Memorandum

Re: Y18/0221/SH – Land Adjoining 27 Cheriton Court Road, Folkestone, Kent

**Drawing Title: General Arrangement Detailed Elevations Plots 331, 332, 333, 334,
Drawing Number 06234-21102-3/44BTH – 51 Rev P3**

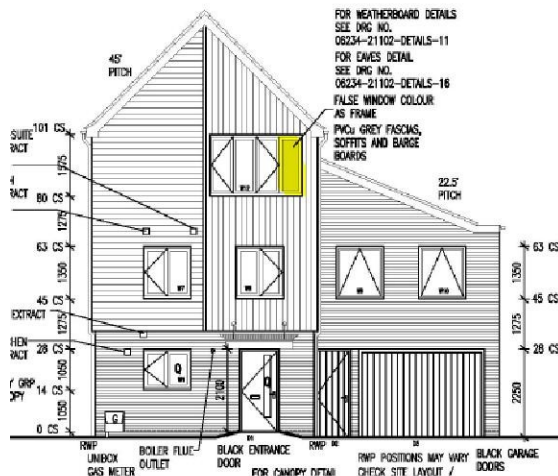
Further explanation required for false window, coloured yellow on drawing. If this is to be removed the second floor window should be repositioned to align with the window and door below.

Please could you confirm if the flat roof section above the garage is necessary, it would be preferable for the mono-pitch roof slope to meet the side of the adjacent property.

**Drawing Title: General Arrangement Detailed Elevations Plots 296, Drawing
Number 06234-21102-PA44 – 51 Rev P3**

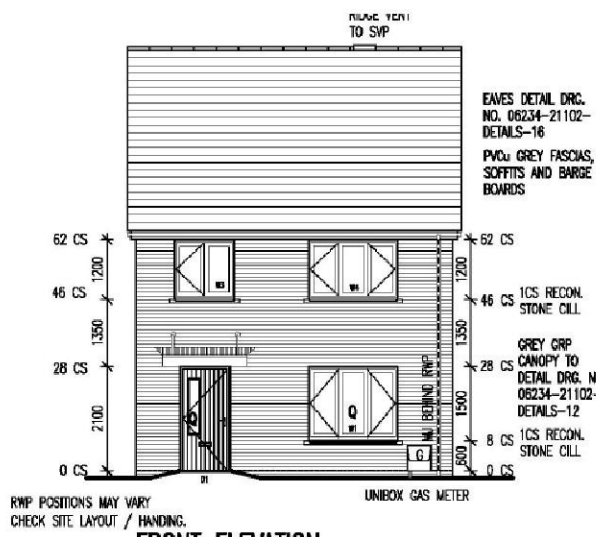
Request stone cills to the rear of the building. Request reconstituted stone lintel over ground floor window on front elevation and over French doors to rear elevation.

Drawing Title: General Arrangement Detailed Elevations Plots 330, Drawing Number 06234-21102-PT37 – 51 Rev P3

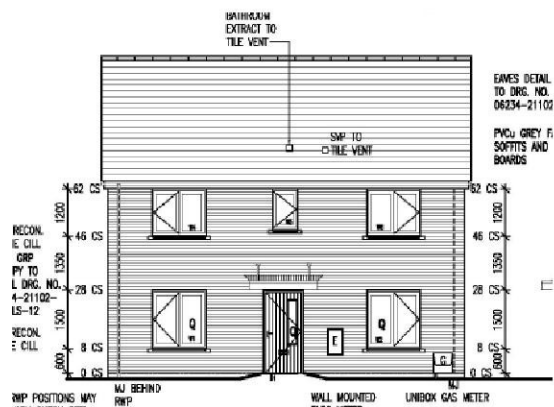
Request reconstituted stone lintel over ground windows on all elevations as appropriate.

Relocate electricity meter to side of building

Drawing Title: General Arrangement Detailed Elevations Plots 295, Drawing Number 06234-21102-PT41 – 51 Rev P2

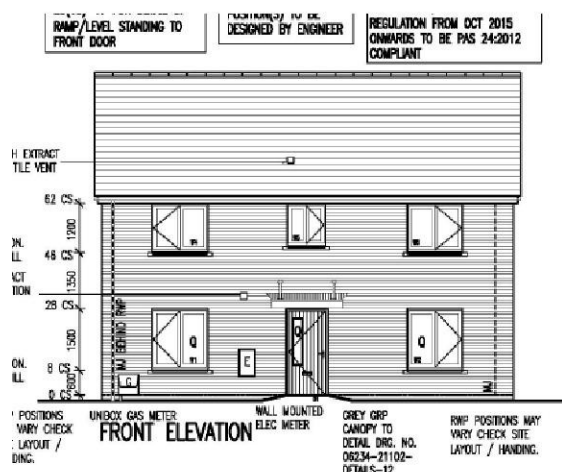
Consider small oriel window above front door.

Relocate electricity meter to side of building

All elevations should have reconstituted stone cills, would suggest addition of reconstituted stone lintels where appropriate

Drawing Title: General Arrangement Detailed Elevations Plots 314, Drawing Number 06234-21102-PT42 – 51 Rev P2

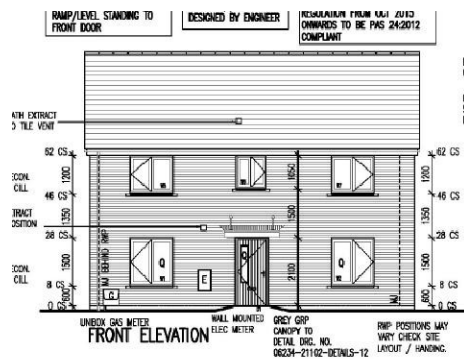
Relocate electricity meter to the side of the building.

Reconstituted stone cills should be included on all elevations and reconstituted stone lintels where appropriate.

Drawing Title: General Arrangement Detailed Elevations Plots 297, 298, 299, 300, 301, 302, 303, 304, 305, 306, 307, 308 Drawing Number 06234-21102-SLA – 51 Rev P4

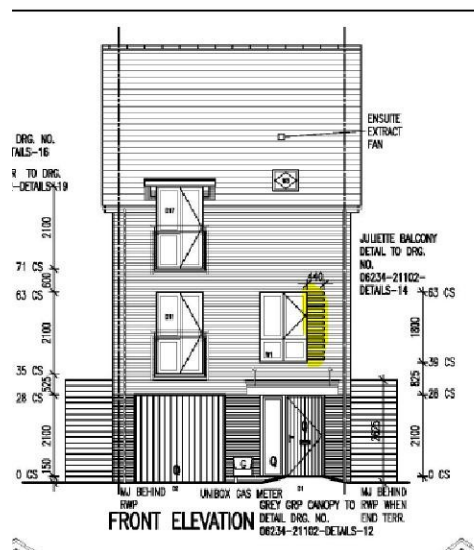
Clarification of detail that is highlighted in yellow, how will this look, is it significant enough? Would it be better to relocate this to the line of windows above the garage doors so that it, in combination with the windows runs the full height of the houses? It could tie into some kind of feature above the garage doors.

Is there differentiation in the lower section of the building as suggested by the drawings?

Drawing Title: General Arrangement Detailed Elevations Plots 309 Drawing Number 06234-21102-SLB – 51 Rev P3

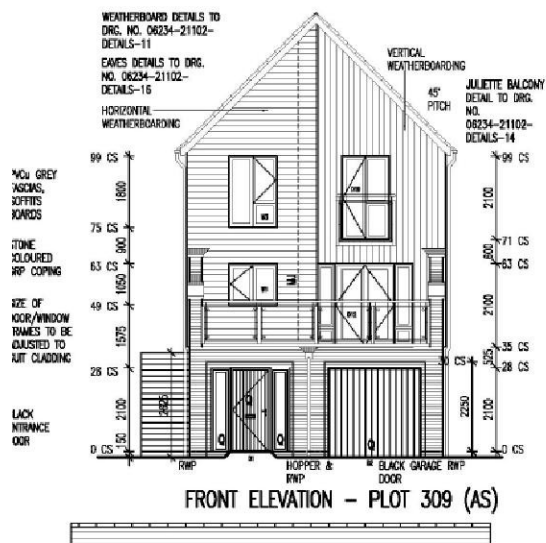
Where are gas and electricity metres planned for? Should be on the side of the building

Drawing Title: General Arrangement Detailed Elevations Plots 310, 311, 312
Drawing Number 06234-21102-SLB – 52 Rev P3

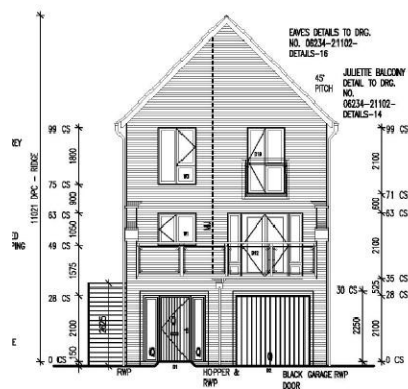
Where are gas and electricity metres planned for? Should be on the side of the building

Drawing Title: General Arrangement Detailed Elevations Plots 323, 324, 325, 326
Drawing Number 06234-21102-SLB – 53 Rev P3

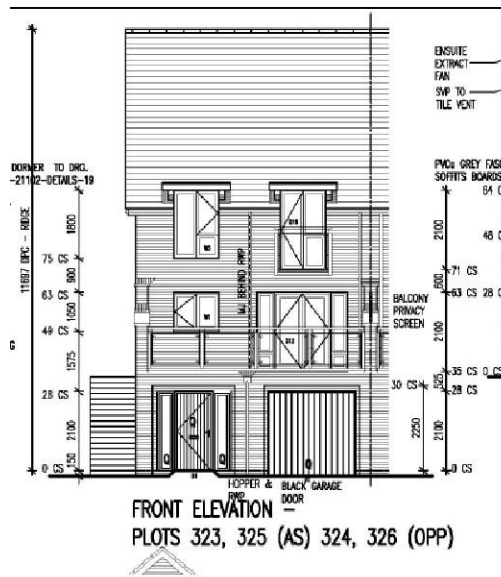
Where are gas and electricity metres planned for? Should be on the side of the building

Drawing Title: General Arrangement Detailed Elevations Plots 327 & 328
Drawing Number 06234-21102-SLB – 53 Rev P3

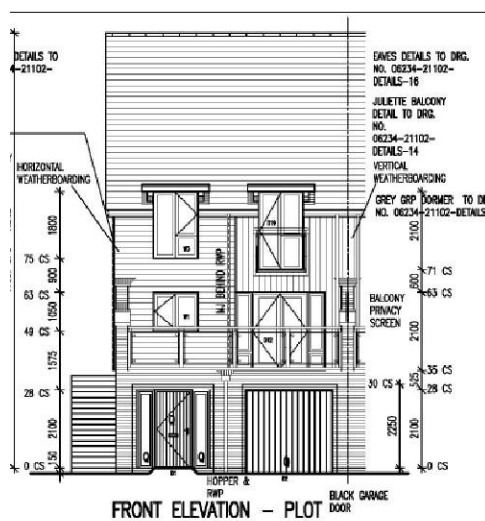
Where are gas and electricity metres planned for? Should be on the side of the building

Drawing Title: General Arrangement Detailed Elevations Plots 318,319 & 320
Drawing Number 06234-21102-SLC – 51 Rev P5

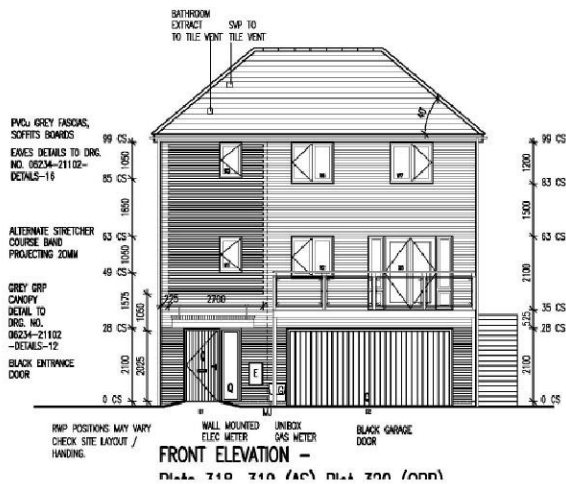
Please confirm brick detailing.

Electricity meters are located on the front of the buildings. These should be relocated to the side.

Larger scale detail of canopy/ balcony would be useful. It may be beneficial to stretch the balcony across the whole of the front elevation and not have the canopy.

Drawing Title: General Arrangement Detailed Elevations Plots 313 Drawing Number 06234-21102-SLC – 52 Rev P5

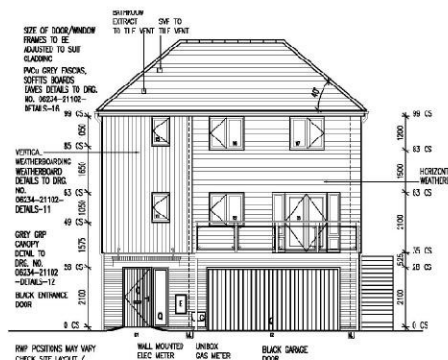
Electricity meter is located on the front of the buildings. This should be relocated to the side.

The drawing appears to be inaccurate. The appearance of the drawing appears to be handed in comparison with the detail (e.g. steps, garage etc.) on the layout plan.

Drawing Title: General Arrangement Detailed Elevations Plots 315 Drawing Number 06234-21102-SLC – 54 Rev P5

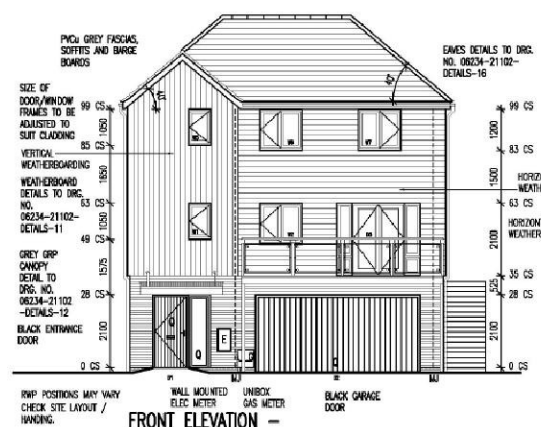
Electricity meters are located on the front of the buildings. This should be relocated
